X 91.145-26

## MODELS 42, 242, 61, 266, 268, 272

## **FUEL HOSE**

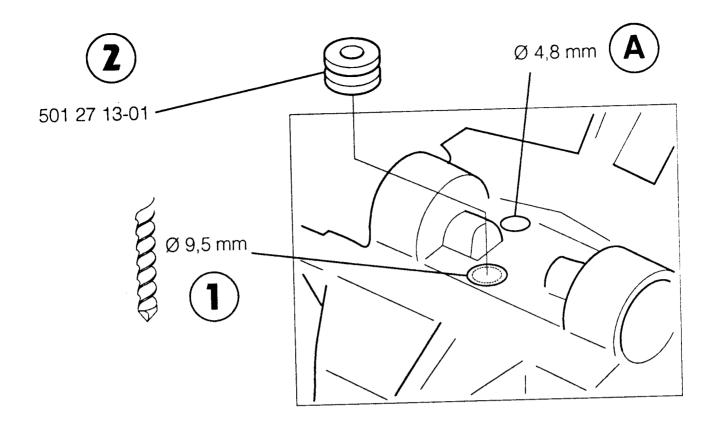
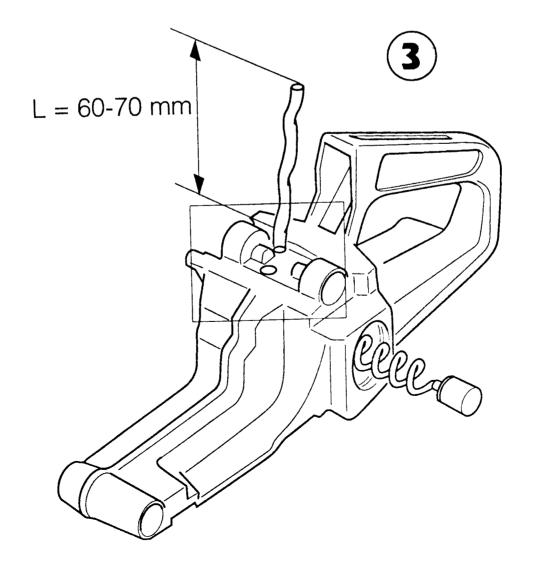
A spiral shaped fuel hose is introduced in our production in order to simplify filter change and to reduce the risk for the filter to get stuck in the tank.

The fuel tank is adjusted to the new hose at the same time. Therefore the hole in the tank is moved (only the models 42/242) and also increased in diameter.

The length of the hose over the fuel tank should be 60-70 mm (extended hose).

Saws with older tanks can use the new fuel hose if the following rework is done. (See the illustration).

- \* Drill a 9,5 mm (3/8") hole in the tank.
- \* Mount the rubber sealing ref. no 501 27 13-01 (266/268, 61/66, 281/288) in the new hole.
- \* Then pull the spiral fuel hose through the hole until a length of (extended hose) 60-70 mm over the tank is received.
